# Process Change Notice #1309274

<b>PCN Date: 9/27/2013</b>		<b>Effective Date: 9/27/2013</b>			
<b>Title: Si2137-A30 &amp; Si2177-A30 Tray change_SPIL_QFN-4x4</b>					
<b>Originator: Paranidharan Rengarajan</b>		<b>Phone: 65-65117735</b>	<b>Dept: Supplier Management</b>		
<b>Customer Contact: Kathy Haggar</b>		<b>Phone: 512-532-5261</b>	<b>Dept: Sales Operations</b>		
<b>PCN Type:</b> <input type="checkbox"/> Datasheet <input type="checkbox"/> Foundry <input type="checkbox"/> Packing <input type="checkbox"/> Product Revision <input type="checkbox"/> Assembly <input type="checkbox"/> Labeling <input type="checkbox"/> Discontinuance <input type="checkbox"/> Test <input checked="" type="checkbox"/> Other					
<b>Last Order Date: Not Applicable.</b>					
<b>PCN Details</b>					
<b>Description of Change:</b> Silicon Laboratories (Silicon Labs) is pleased to announce that a change is being made to the shipment media of Si21xx QFN-4x4 devices. Per the effective date of this PCN, there will be a change in Tray vendor from Shinon to Sunrise for trays only.  The tray dimensions for current and new tray are identical; except cavity wall height in tray bottom. The cavity wall for new tray is

**Pocket Design & Dimension of Shinon Tray (QFN-4x4):**

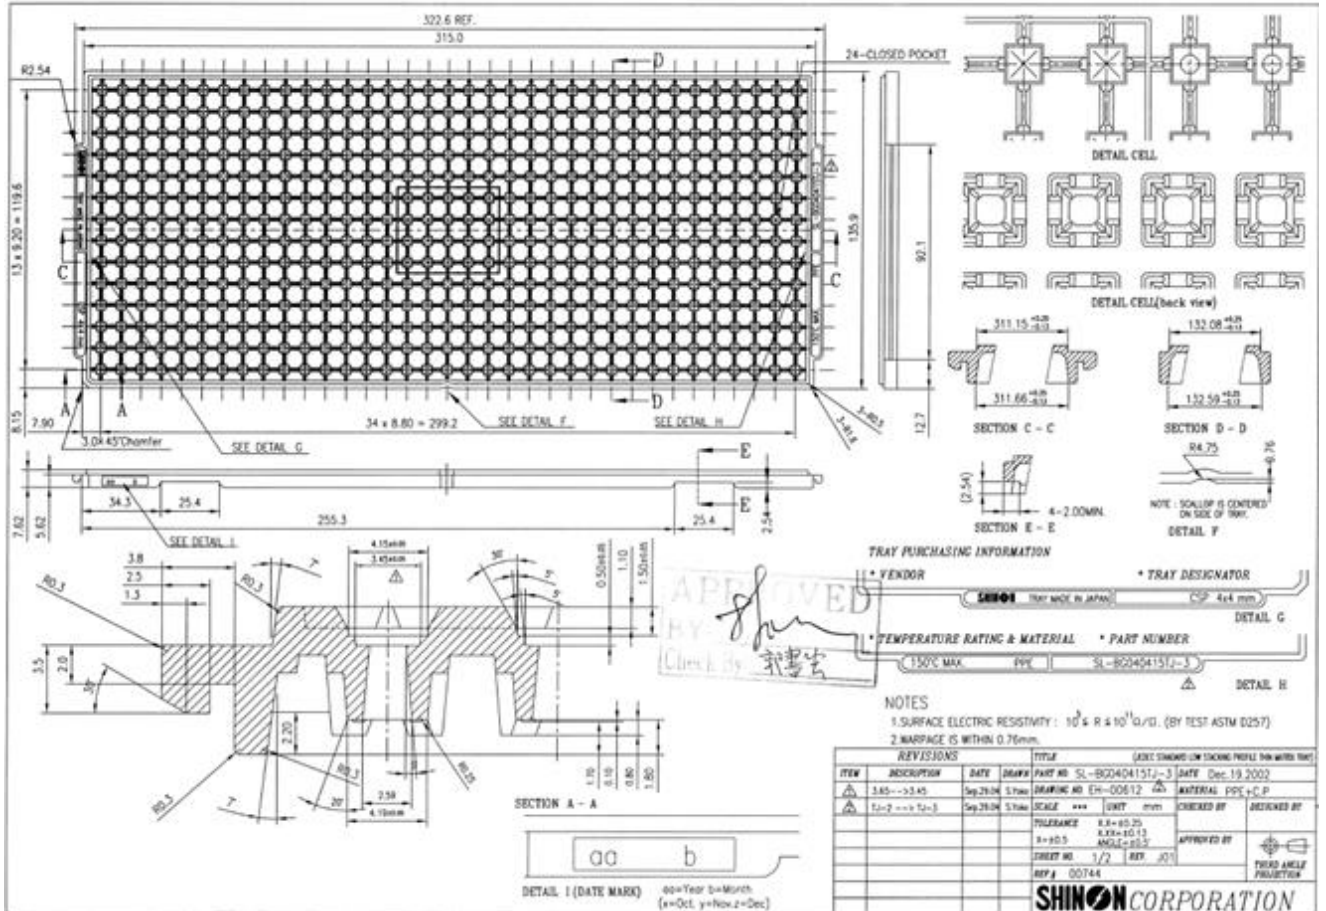
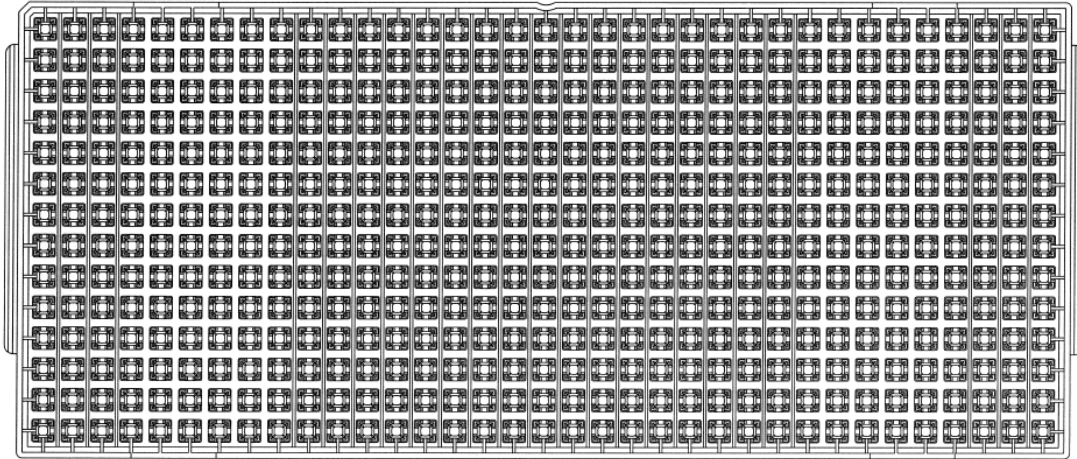
See Appendix B for Tray Drawings.
